PARK CITY MUNICIPAL CORPORATION
ADMINISTRATIVE PUBLIC MEETING MINUTES
PLANNING DEPARTMENT
<https://us02web.zoom.us/j/88167820277>
April 17, 2025

64 Chambers Avenue – Historic District Design Review – PL-24-06360 – The Applicant Proposes to Construct a Rear Addition to a Landmark Historic Structure in the Historic Residential - 1 Zoning District.

64 Chambers Avenue south elevation showing the grade.

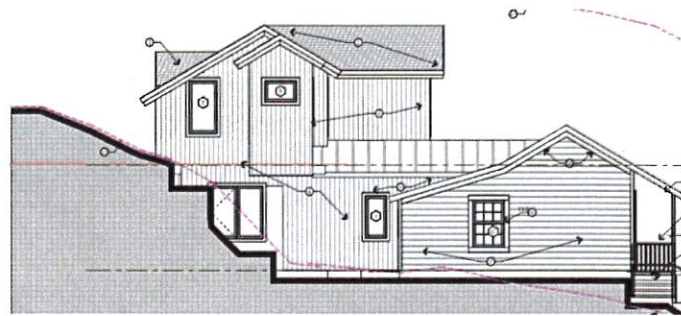
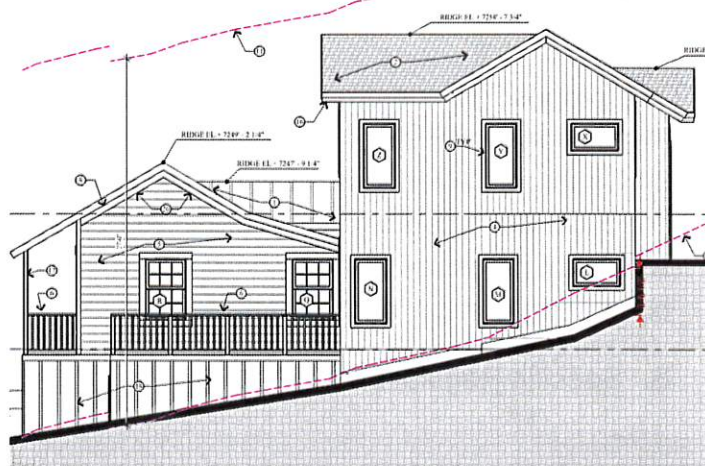
Final Grade within 4 feet of
Existing Grade

Complies: The proposed Final Grade is proposed to be within four feet of Existing Grade.

Garage site plan.

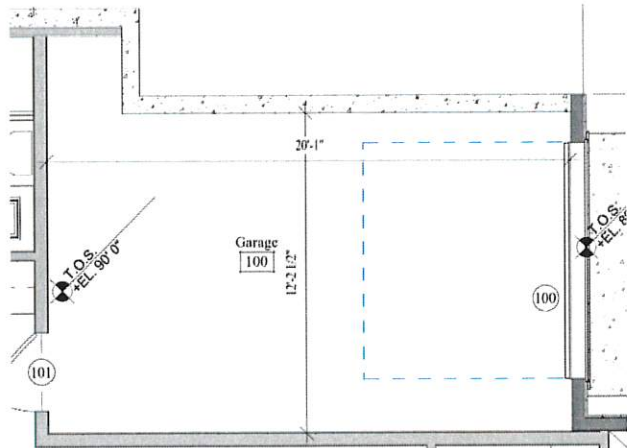
LMC [§ 15-3-6\(A\)](#) requires two parking spaces for a SFD. However, LMC [§ 15-2.2-4](#) exempts Historic Structures from required parking. The Applicant proposes one parking space. LMC [§ 15-3-4\(A\)\(1\)](#) requires a parking space in a garage to be 11' wide by 20' deep. The parking space in the garage measures 12' by 20' and is compliant.

Interior plans showing the transitional element dimensions.

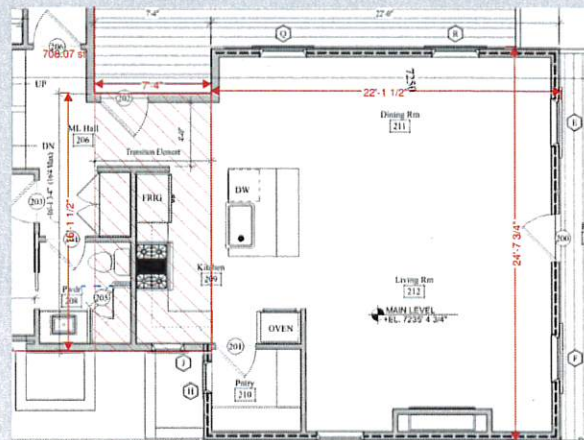
The Historic Structure is approximately 22 feet wide by 24 feet, seven inches deep (540 square feet). The proposed rear addition is approximately 708 square feet, and 131% of the Historic Footprint. Therefore a transitional element is required.

The maximum transitional element measurements width is 16 feet, four inches and the minimum transitional element depth is six feet, 5 1/2 inches.

The Applicant proposes a transitional element that is 16 feet, 1 3/4 inches wide by seven feet, four inches deep and compliant.
